REVISED RESPONSE TO REQUEST FOR ADDITIONAL INFORMATION**APR1400 Design Certification****Korea Electric Power Corporation / Korea Hydro & Nuclear Power Co., LTD****Docket No. 52-046****RAI No.: 318-8337****SRP Section: 15.06.05 – Loss of Coolant Accidents Resulting From Spectrum of Postulated Piping Breaks Within the Reactor Coolant Pressure Boundary****Application Section: 15.6.5****Date of RAI Issue: 11/24/2015****Question No. 15.06.05-2****SBLOCA Break Spectrum Analysis & Core Two-Phase Level**

Response – (Rev. 1)

Figure 15.6.5-24A 126.7 cm² (0.1364 ft²) Break in DVI Line: Normalized Total Core Power

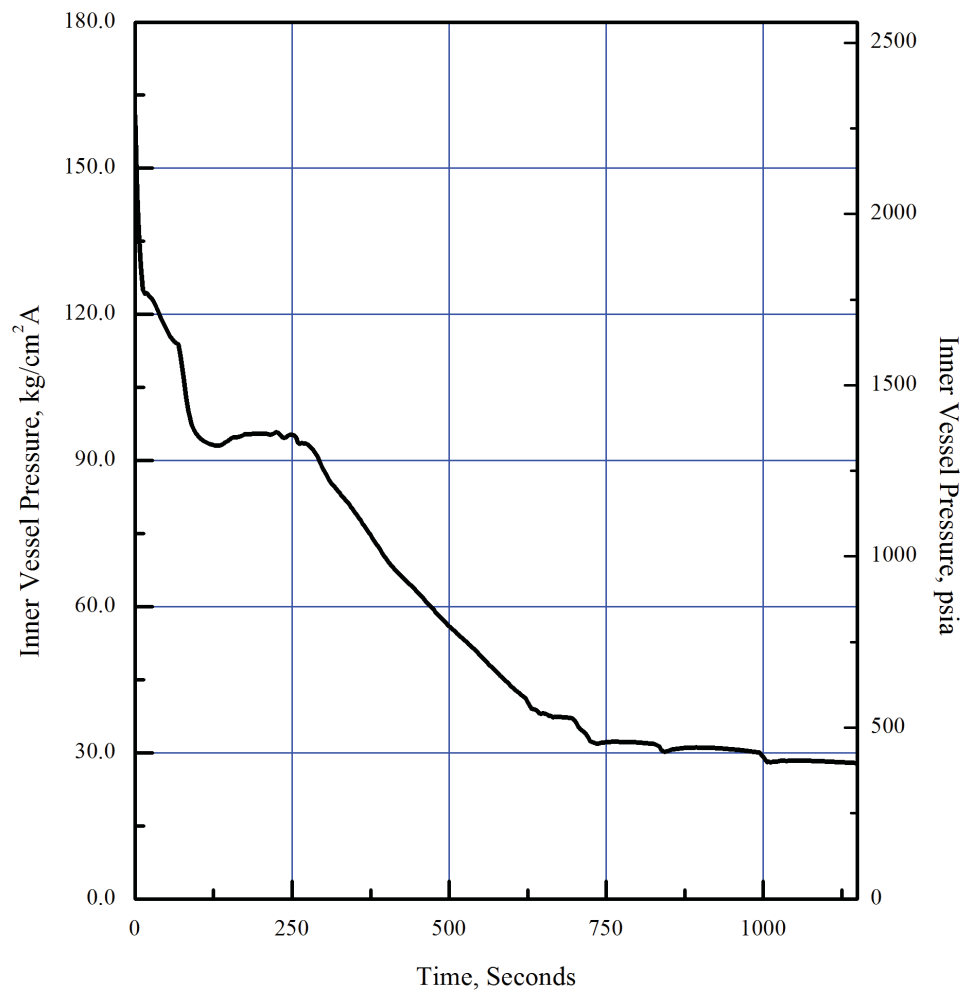
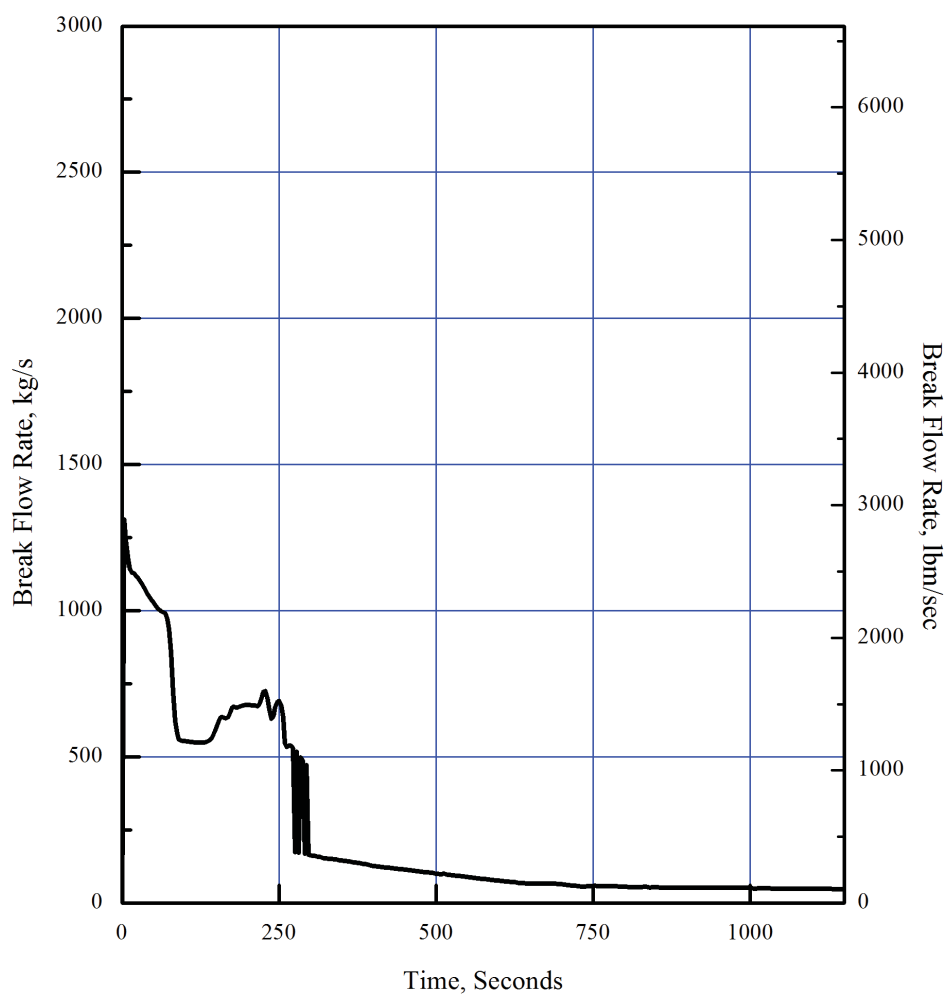
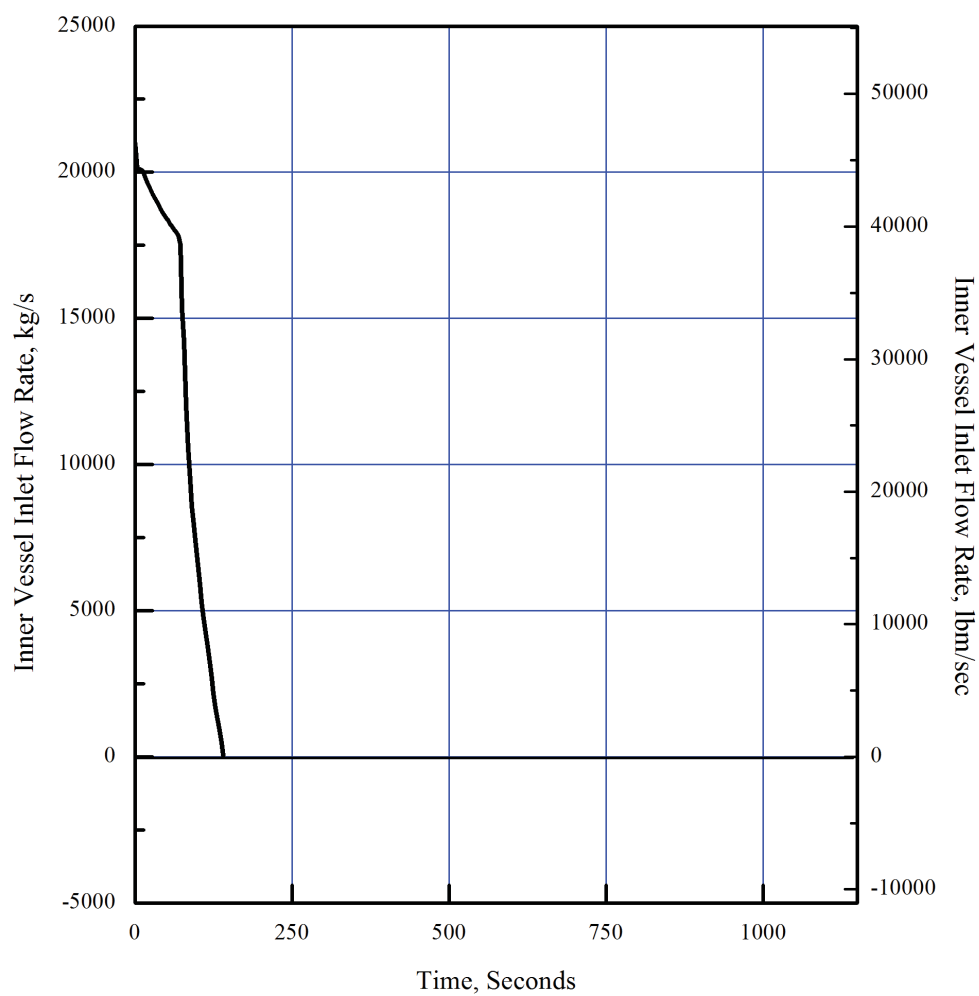
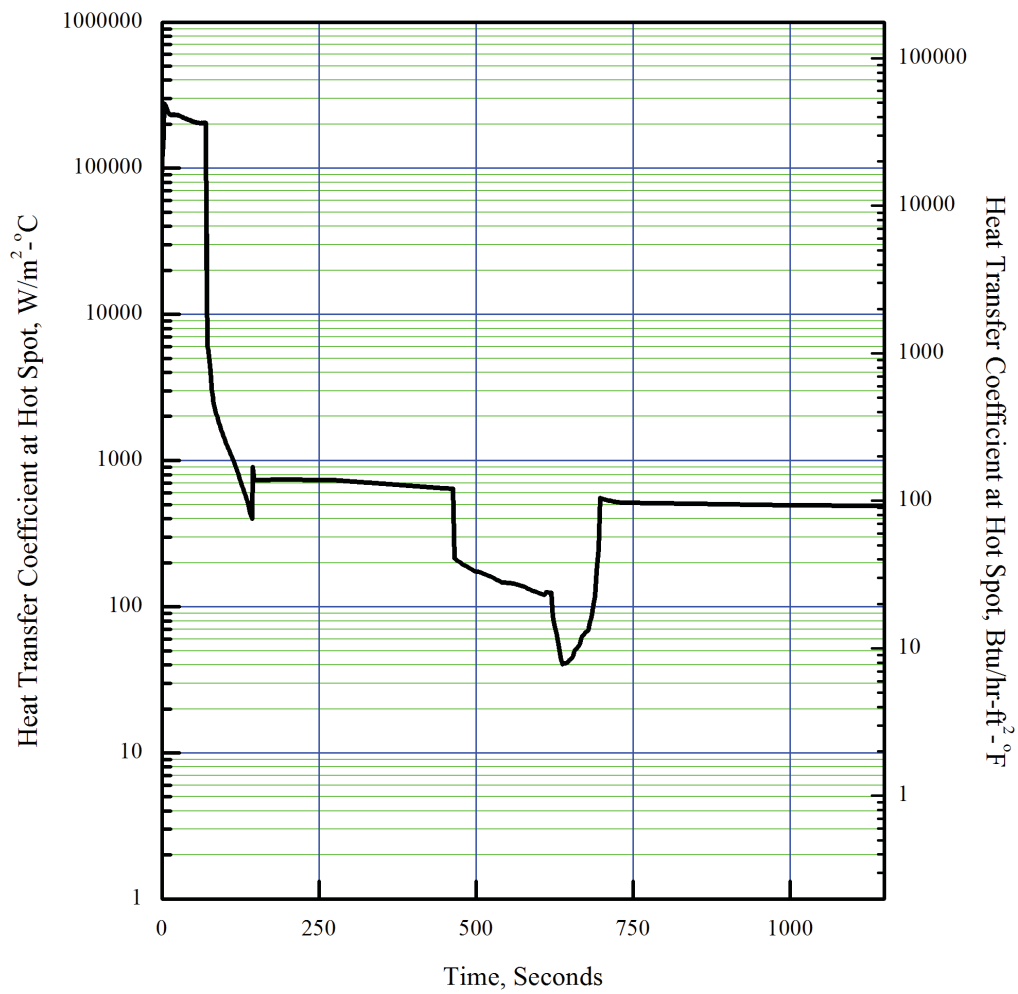
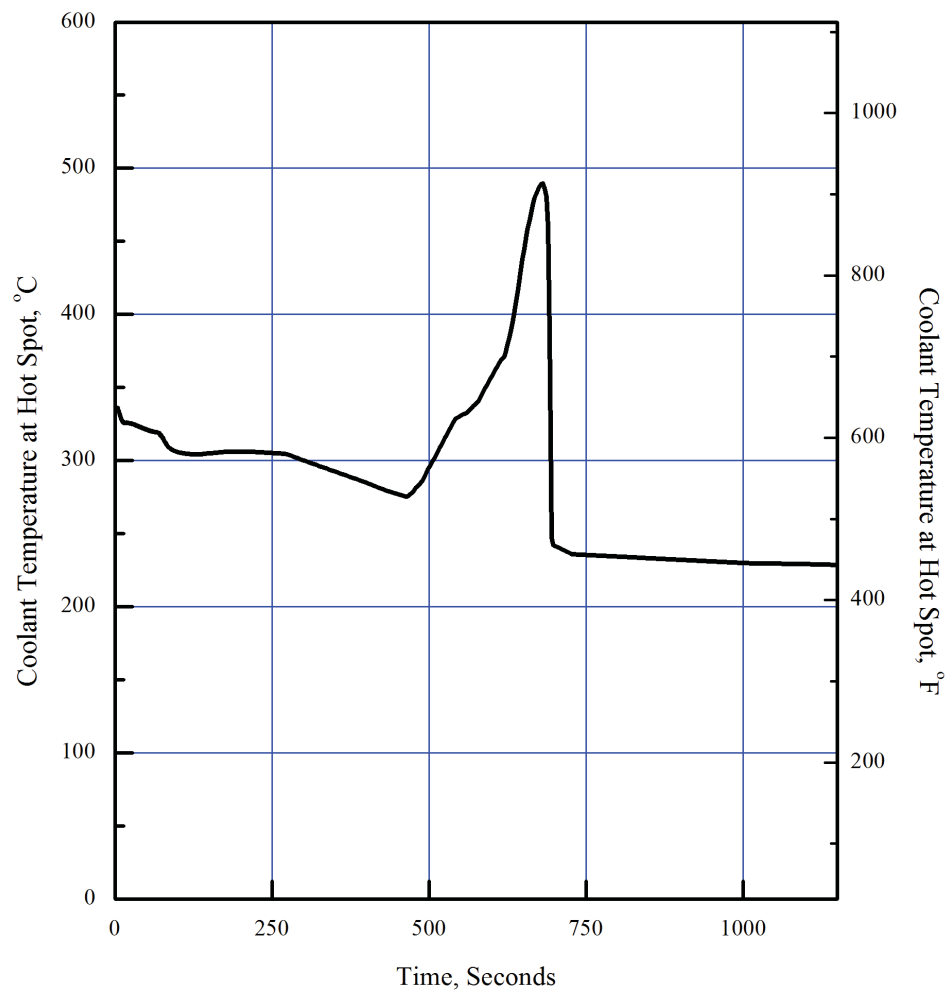
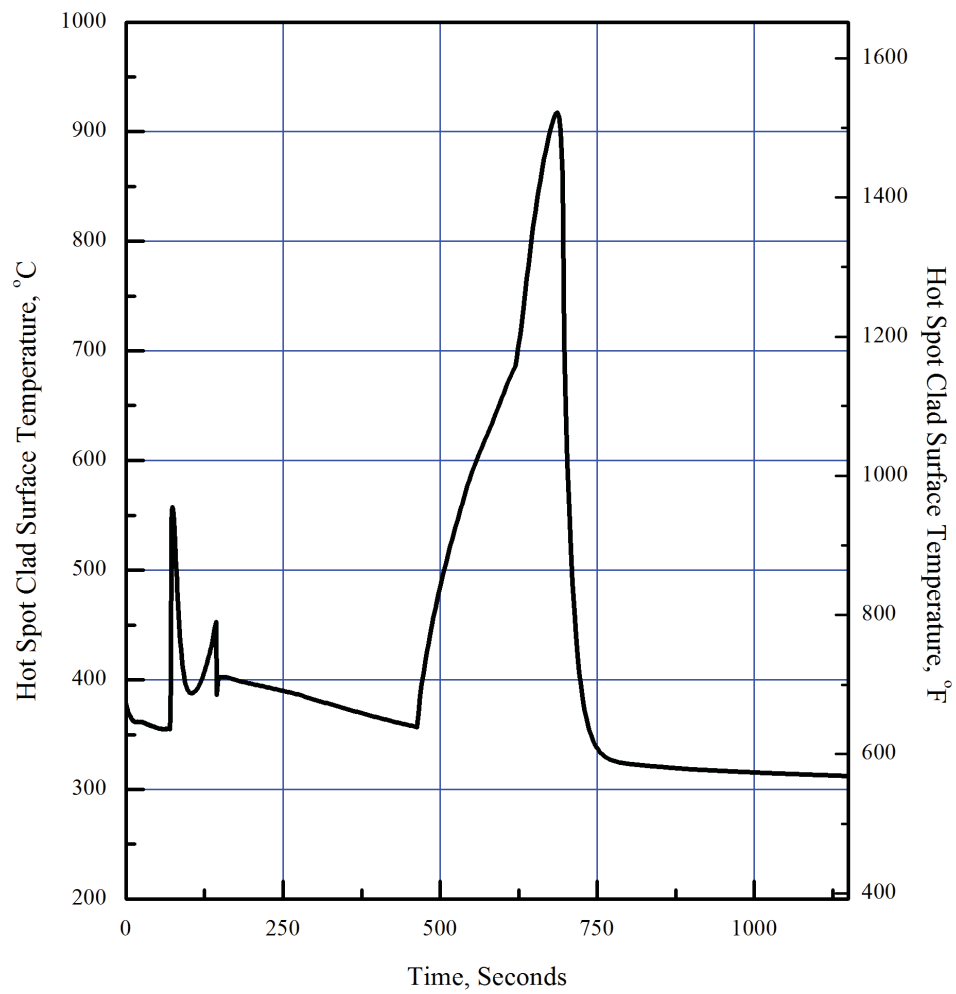
Replace with A

For the DVI line break location, as the break size becomes progressively smaller than 372 cm² (0.4 ft²), the inner vessel two phase level follows a definite pattern:

This trend continues until the core does not uncover at all. These trends predictably affect the PCT.

The core uncover does not occur less than the 31.68 cm² (0.0341 ft²)
